Service Bulletin

SUBJECT: Service Update for Inventory and Customer Vehicles
Driver Airbag Inspection - Expires with Base Warranty

MODELS: 2012 Chevrolet Cruze

2759759

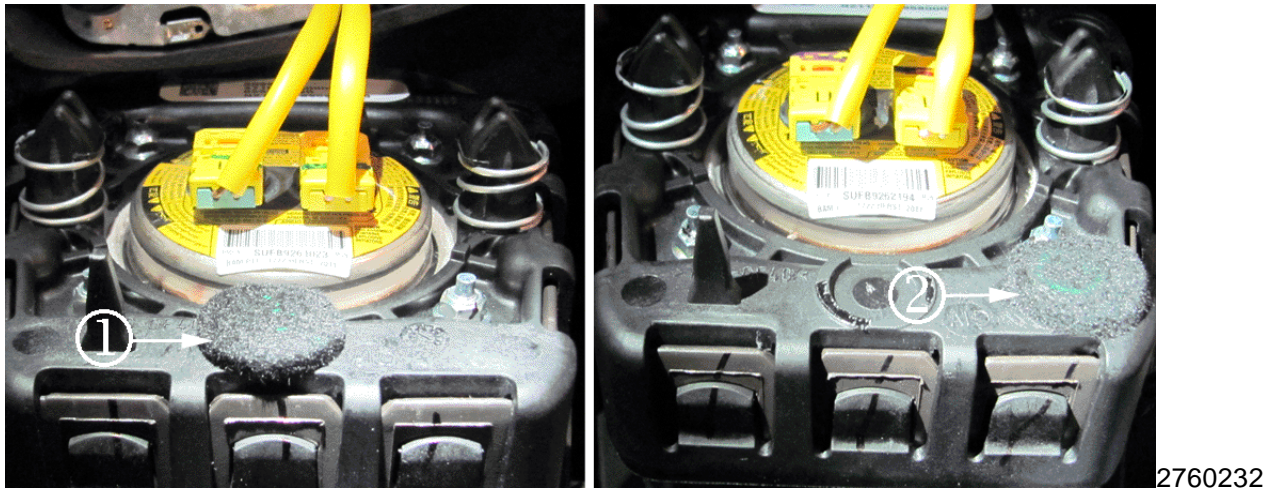
1. Determine if the steering wheel inflatable restraint module has been inspected and repaired. Turn the steering wheel 90 degrees to the right and look for a white dot (1) in the recessed pocket area on the back side of the steering wheel spoke.
 - If a white dot is NOT present, proceed to step 2.
 - If a white dot is present, no further action is required.
2. Disable the supplemental inflatable restraint (SIR) system. Refer to *SIR Disabling and Enabling* in SI.
3. Turn steering wheel 180 degrees to access the module release points on top of the column.
4. Insert suitable tools to the openings on both sides of the steering wheel.
5. Release the springs in direction of the arrows.

Note: Do NOT remove the electrical connectors on the module. Relocating the felt patch can be achieved without removing the electrical connectors on the module. Some airbag modules may not have a felt patch. If the airbag module does not have a felt patch, reassemble the airbag module without the felt patch.

6. Remove the felt patch from the 6 o'clock position (1) and re-install it in the 5 o'clock position (2) as shown in illustration. The felt patch edge should be in line with the edge of the airbag module. The felt patch should not hang over the airbag module edge.
7. Align the steering wheel module fasteners to the steering column fastener holes.

Warning: To avoid personal injury or part damage, ensure the steering wheel module fasteners engage into the steering column. Lightly pull on the sides of the module at the 11 o'clock and 1 o'clock position to ensure the module is engaged into the steering column.

8. Push the steering wheel module firmly into the steering column in order to engage the fasteners. Listen for two clicks to ensure both attachment pins are engaged.
9. Enable the SIR system. Refer to *SIR Disabling and Enabling* in SI.
